QUESTION Reinforcing Steel
5J.1

QUESTION 5J.2 Describe the pressure/thermal load in the liner.

FIGURE 5J.6.6-1
PLANT EXCAVATION PLAN

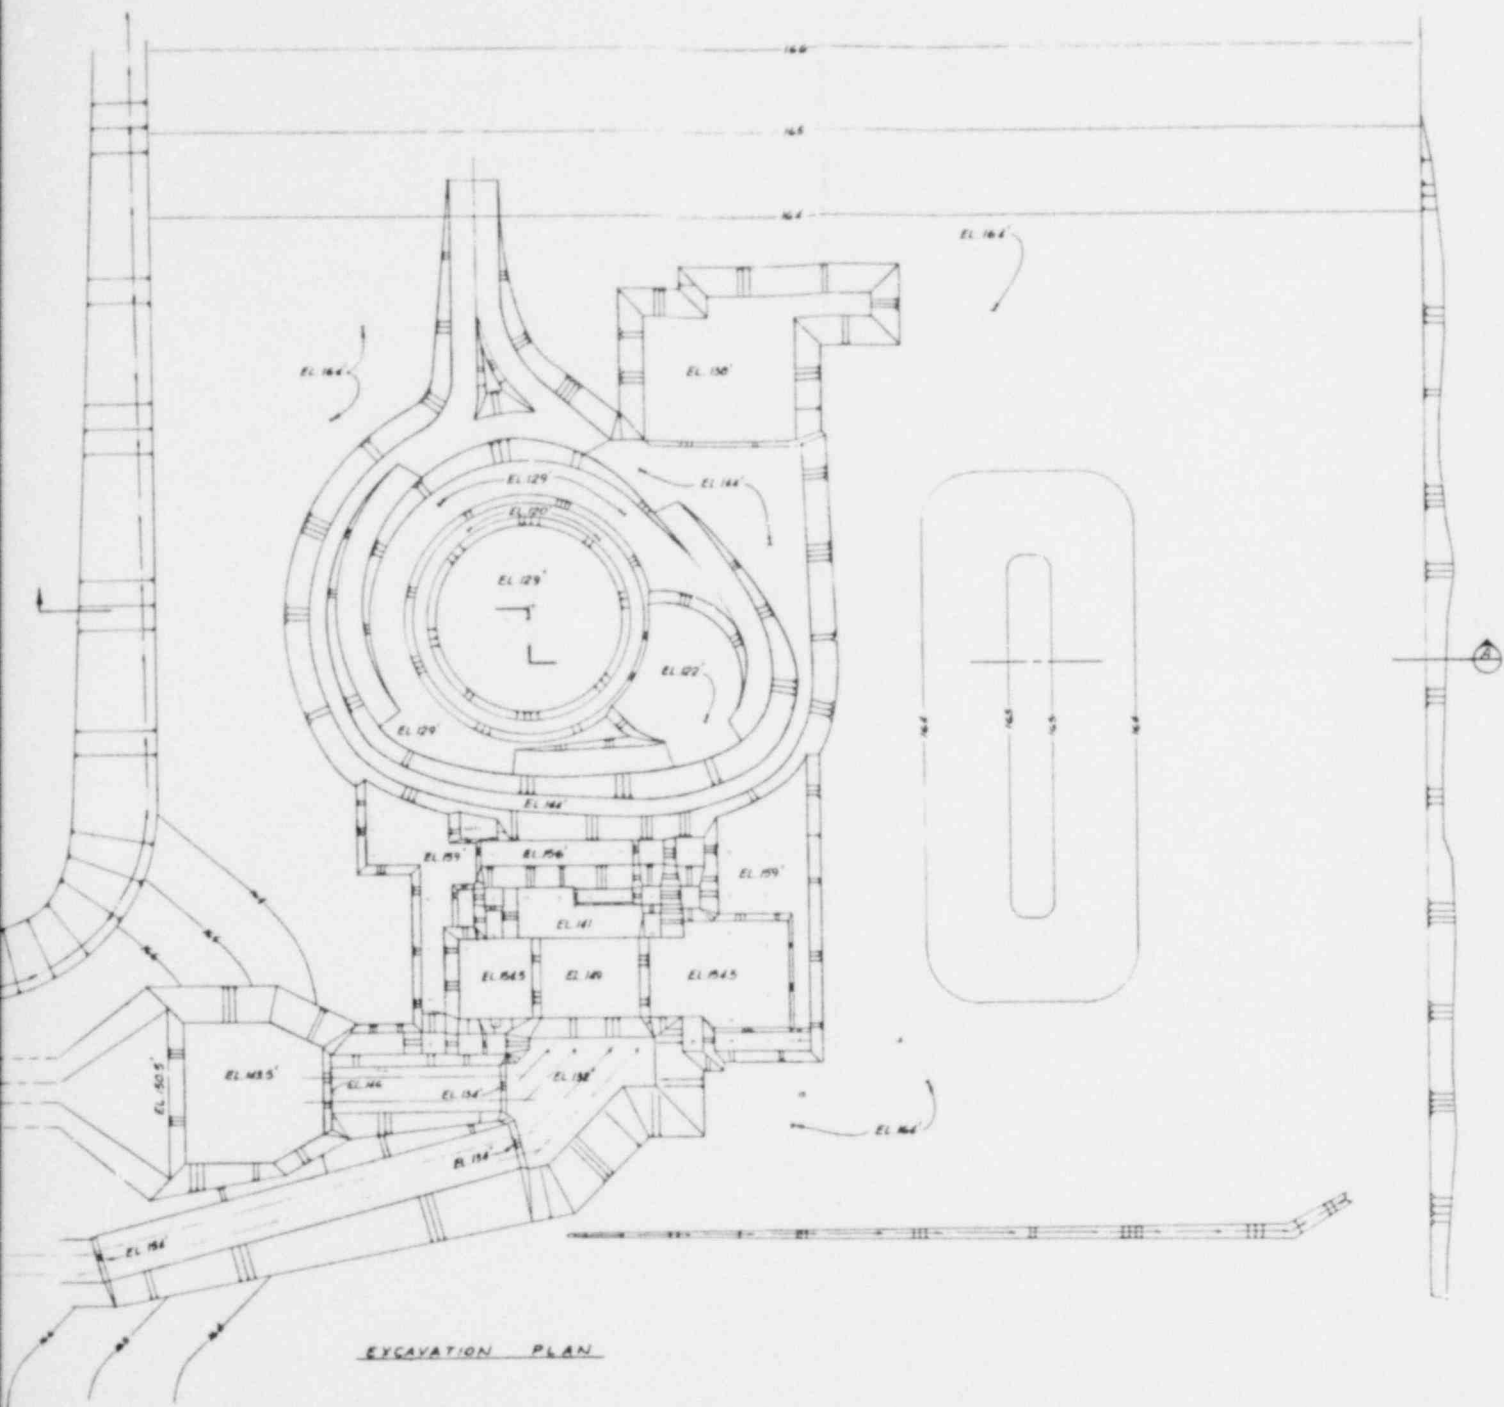
It appears from the PSAR that the foundations of the containment and other structures will rest on layers of sands, gravels, silts, and silty clays. It is not stated whether these materials are insensitive to accelerated weathering, or whether they expand when exposed to the atmosphere, during construction. Provide information on:

- (a) The extent to which the above are true;
- (b) The construction procedure that will be used to avoid damage to these materials during the time interval between excavating and installing of foundations; how they will be protected;
- (c) What the shape of the excavation will be; how the excavation will be drained;
- (d) The provisions that will be made to accommodate differential settlements during earthquakes.

- (c) The rough excavation will be a plane at elevation 164 ft± sloping away from the major structures at from 0 to 2 percent to the plant storm drain systems. Overland flow will be intercepted at the perimeter of

the excavation and carried around the plant in surface ditches and through the plant in buried pipe. The excavation for the containment, turbine building, and auxiliary building will be lower than the surrounding natural drainage channels. The soil surface runoff resulting from rainfall over the excavated areas for the containment, turbine building and auxiliary building will have to be pumped out of these areas by the constructor of the storm drain system. Due to the configuration of the excavation for these structures, sumps will probably be required in the containment area, the turbine building area, and the radwaste area. The preliminary plant excavation plan is shown in Figure 5J.6.6-1.

FIGURE 5J.7.2-1
 CONTAINMENT STRUCTURE STRESS ANALYSIS
 PRELIMINARY MANUAL CALCULATIONS
 DEAD LOAD (D)

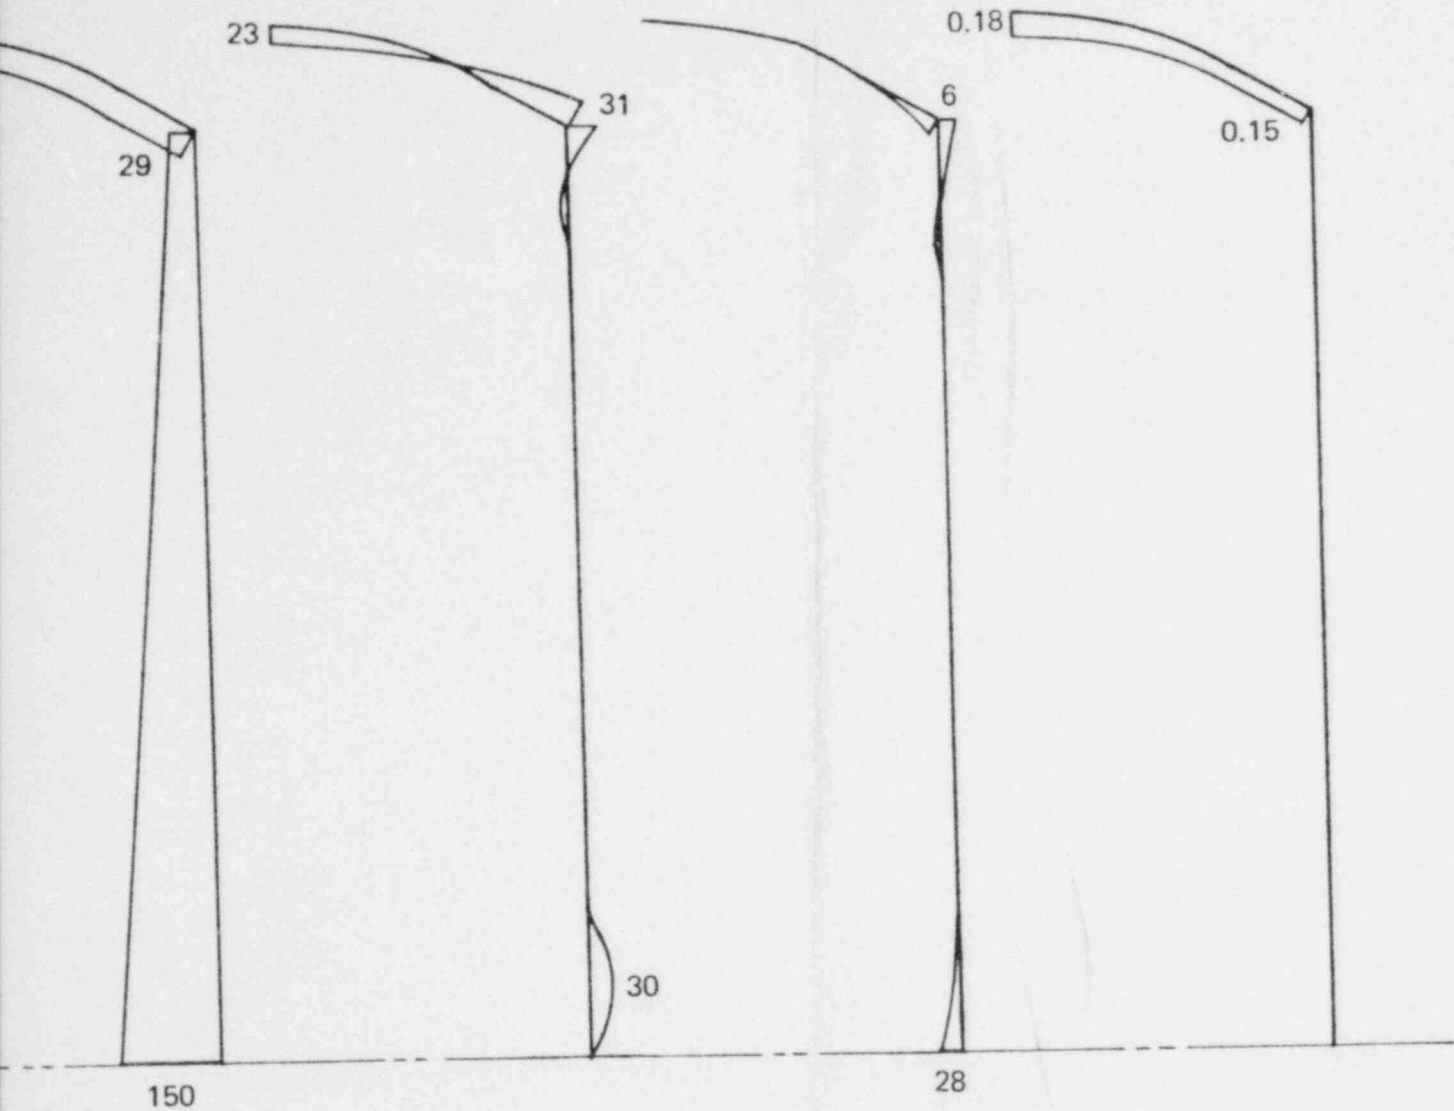
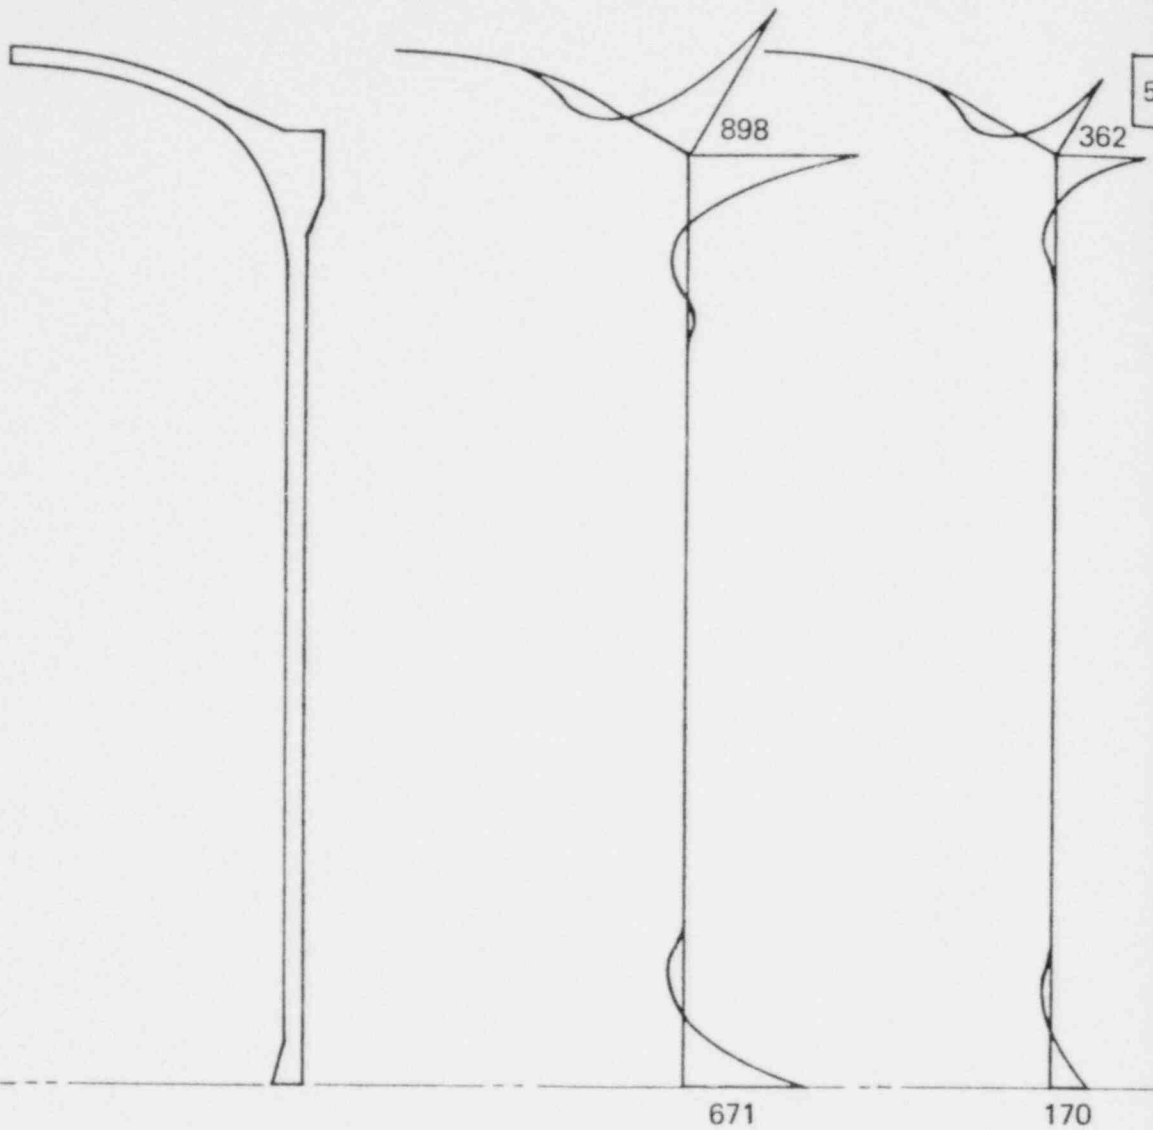
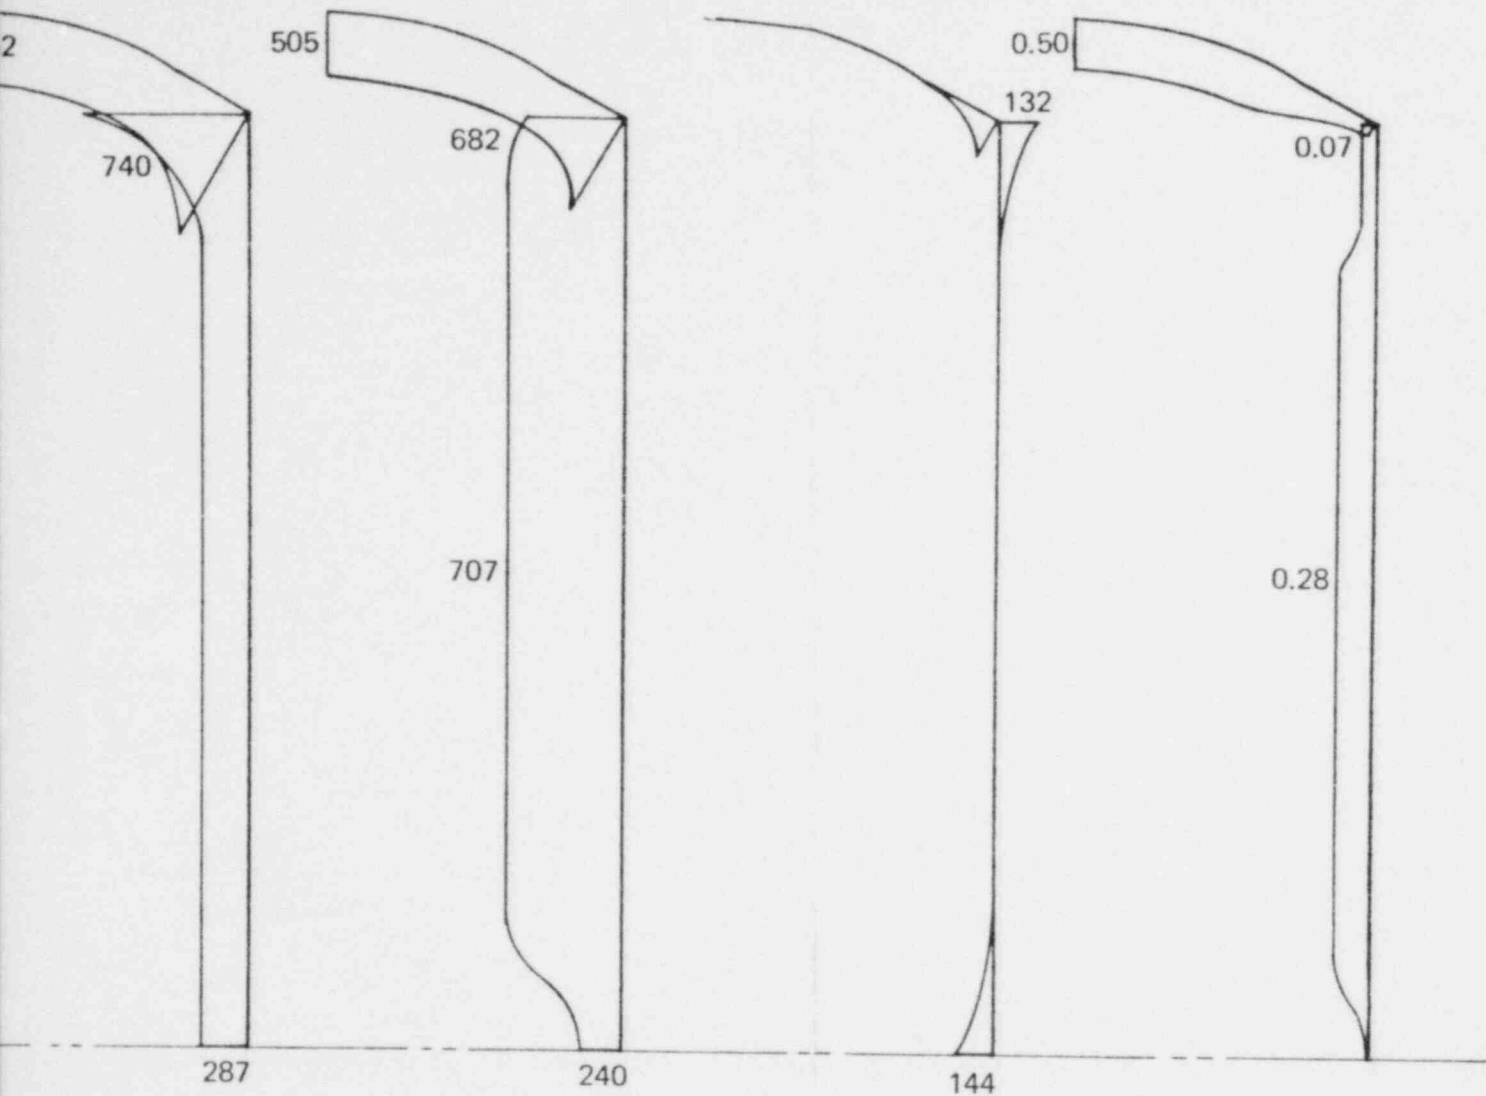
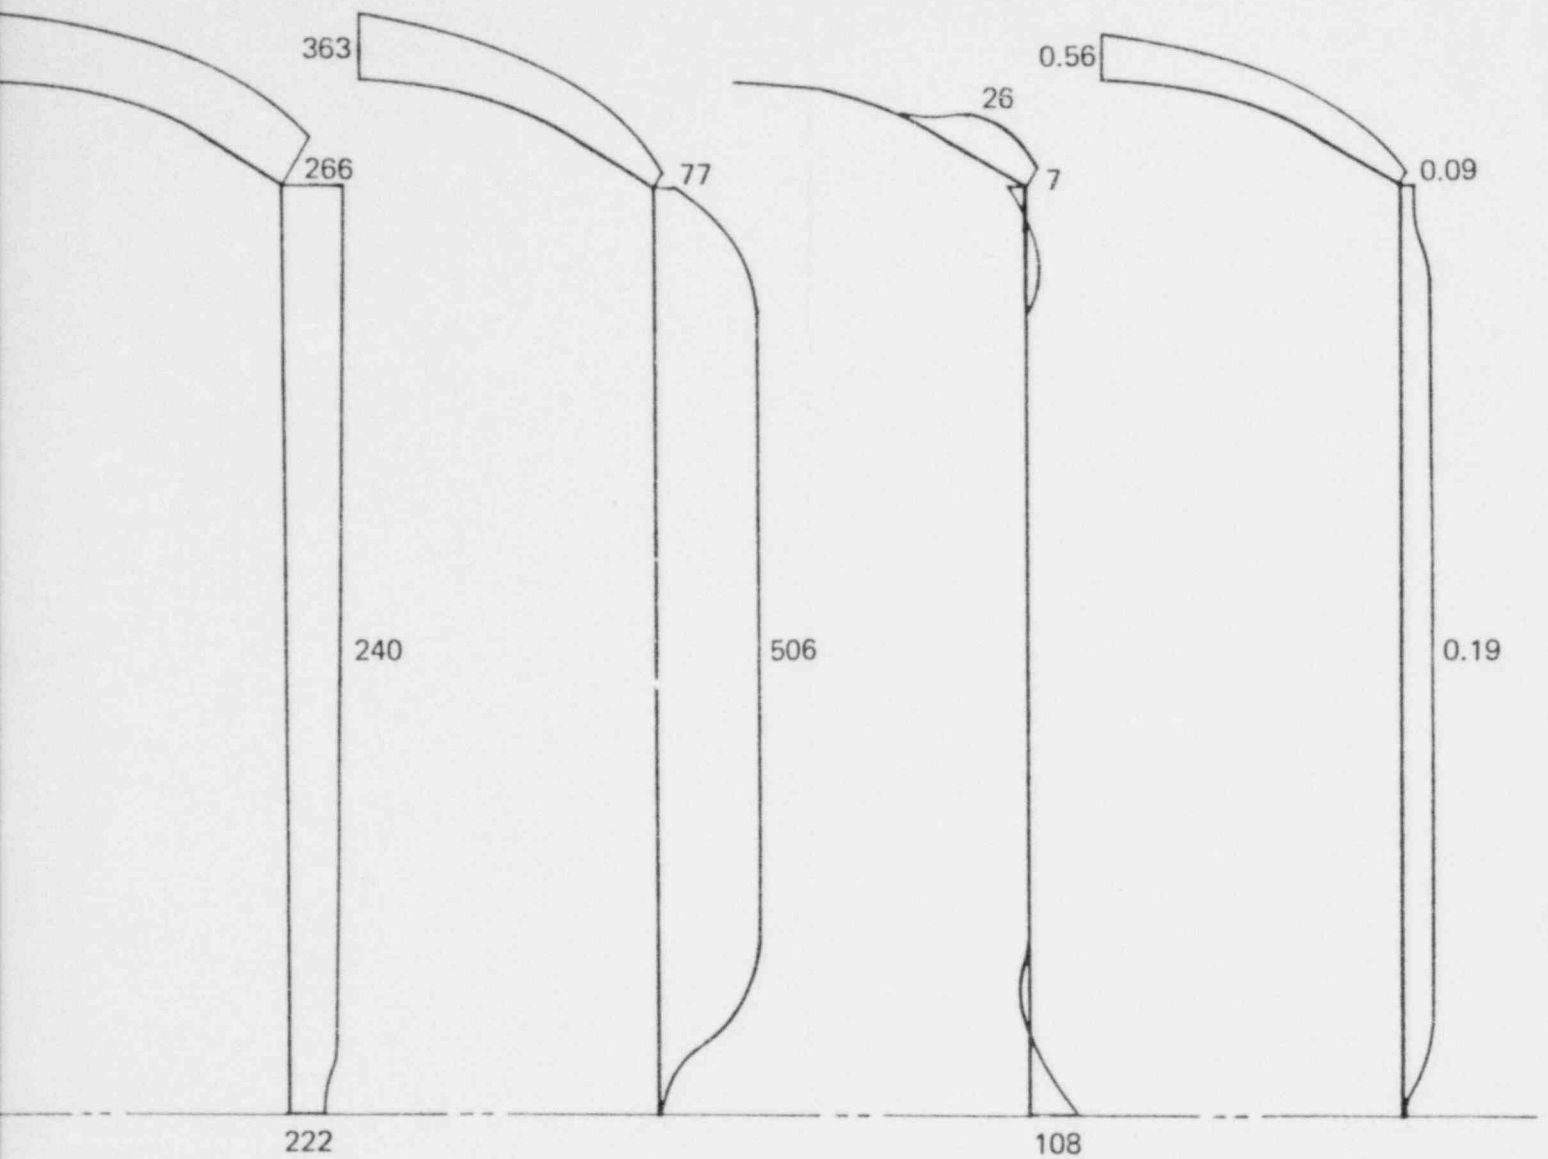
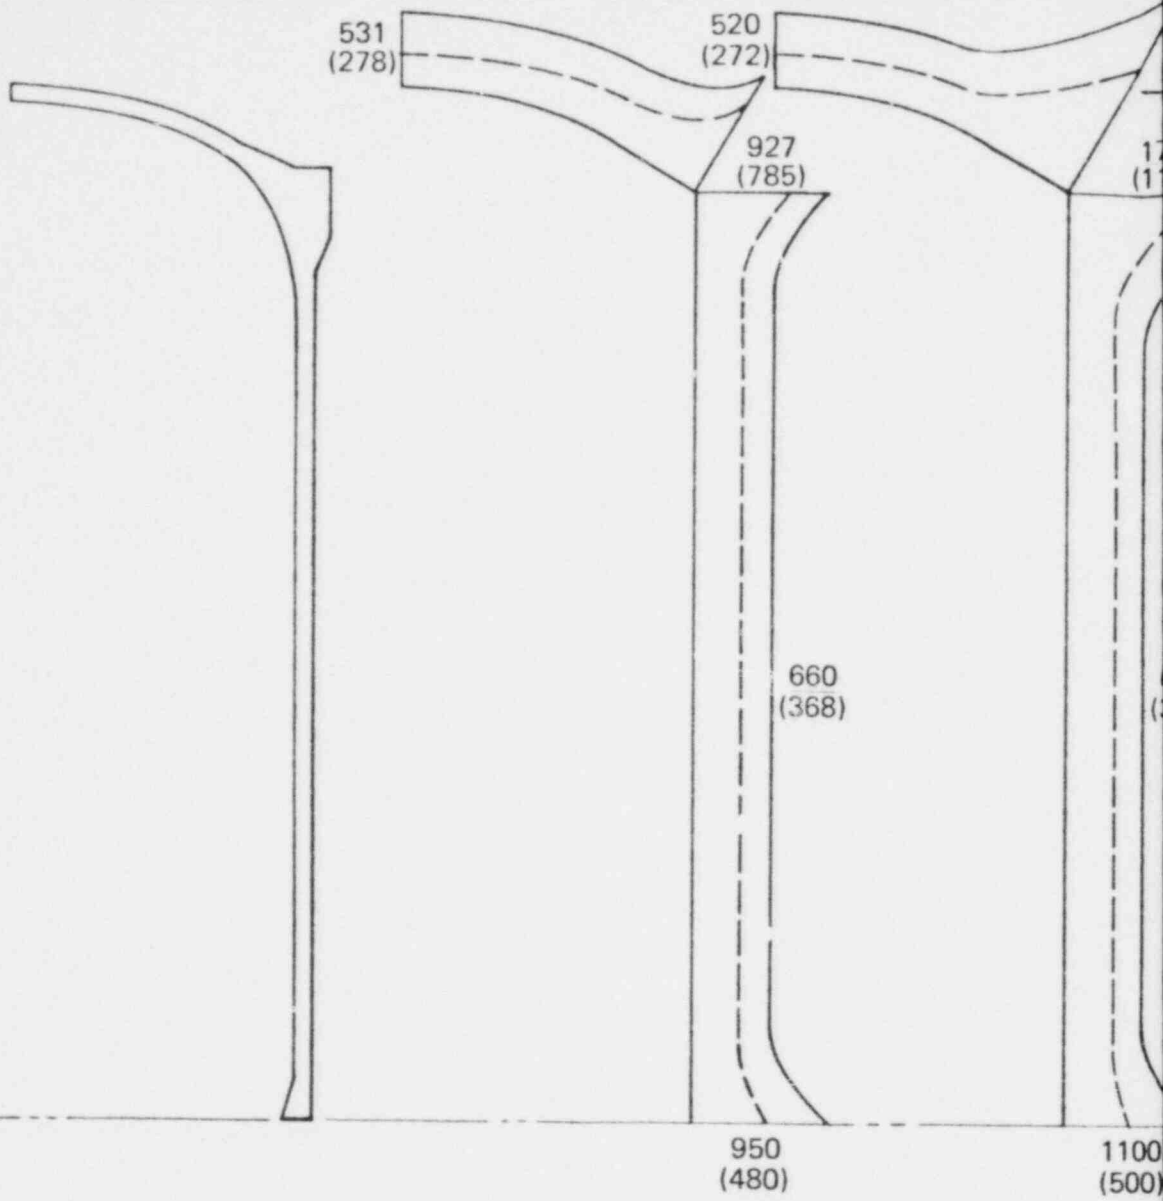
Provide the following:

- (a) A preliminary design drawing of the containment, presenting details of the base slab, dome ring beam, cylinder-slab juncture, vertical buttresses and inspection gallery; showing reinforcing, prestressing, and liner features, including liner anchors;
- (b) Scaled load plots for moment, shear, deflection, longitudinal force, and hoop tension, in order that an appraisal can be made of the significance of the various loadings which influence the containment design; Provide these plots as a function of containment height for prestress, dead, pressure, design earthquake, wind, liner thermal (normal and accident) and concrete thermal (normal and accident) loading;
- (c) The normal operating transient and steady state thermal gradients to be used in the design of the containment for typical winter and typical summer day;

- (b) Preliminary scaled load plots for moment, shears, forces, and deflections are included in Figures 5J.7.2-1 through 5J.7.2-6 for all loading conditions. A plot of the thermal loading of the liner plate has been excluded due to the nature of its membrane action under prestress and thermal conditions. However, a description of this action is discussed in Questions 5J.7.4, 5J.7.18, 5J.7.19 and 5J.7.20 as well as Sections 5.1.3.4, 5.1.4.6 and 5.1.4.9 of the PSAR.
